**Proposed 'Government Use' (GBA Air Quality Laboratory and
Meteorological Monitoring Supersite and Associated Filling of Land)
in "Green Belt" Zone and Area shown as 'Road',
Government Land in D.D.129, Deep Bay Road, Tsim Bei Tsui,
Yuen Long, New Territories
(Section 16 Planning Application No. A/YL-LFS/592)
- Further Information No. 4 -**

(S.16 Planning Application No. A/YL-LFS/592)

Comments Forwarded from Tuen Mun and Yuen Long West District Planning Office

**DRAINAGE PROPOSAL
FOR
PLANNING APPLICATION FOR
GREATER BAY AREA AIR QUALITY LABORATORY
AND METEOROLOGICAL MONITORING SUPERSITE
AT TSIM BEI TSUI**

PROPOSED STORMWATER DRAINAGE PLAN

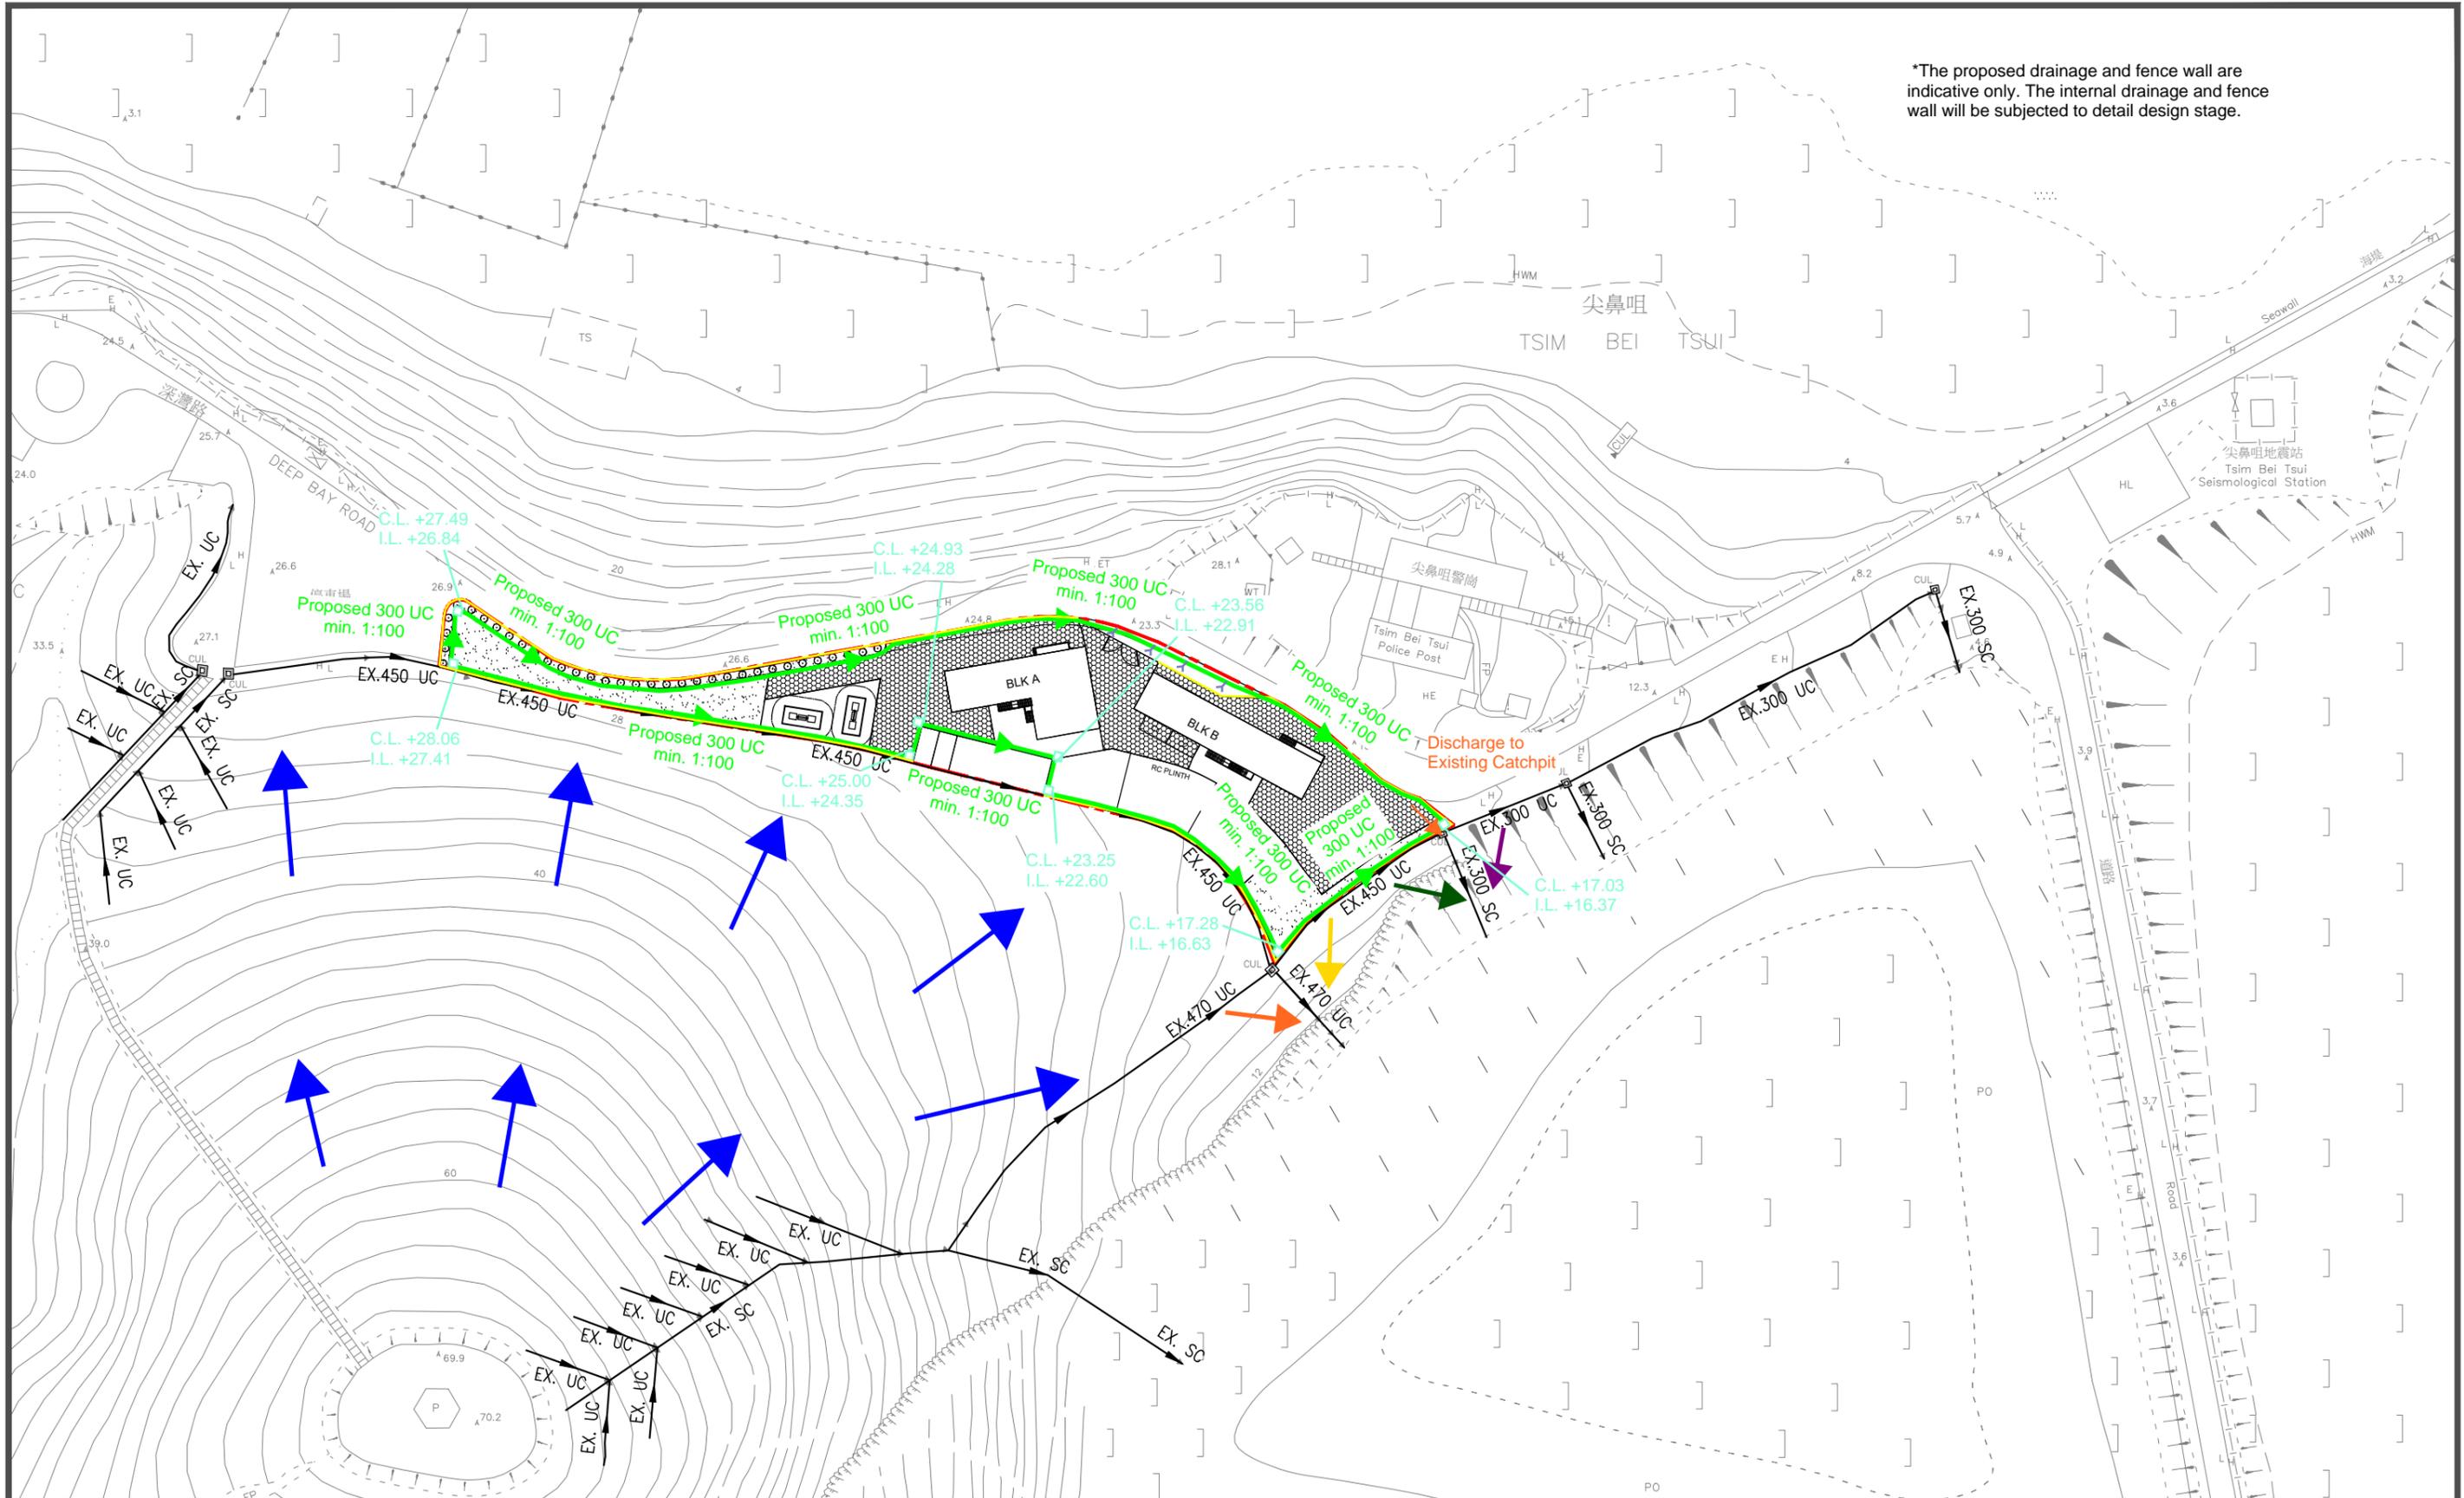
Comments	Responses
<p>Comments from Drainage Services Department (received on 5 February 2026) Contact person: Mr. Terence TANG; Tel. No.: 3965 8927</p>	
<p>I have the following comments on the submitted drainage proposal:</p> <p>(a) The applicant should address the comment at this planning stage. Consideration should be given to provide catchpit at the turning points of the u-channel.</p>	<p>Indicative catchpit is proposed at the turning points of the u-channel. The internal drainage layout and detail will be subjected to detail design stage.</p>
<p>(b) The applicant should address the comment at this planning stage. The cover and invert levels of the proposed u-channels and catchpits should be shown on the drainage plan.</p>	<p>The cover and invert levels of the proposed catchpits are indicated on the proposed stormwater drainage plan in Appendix G of the Drainage Proposal. The proposed u-channels will be proposed with a minimum 1:100 fall according to the adjacent catchpit level.</p>
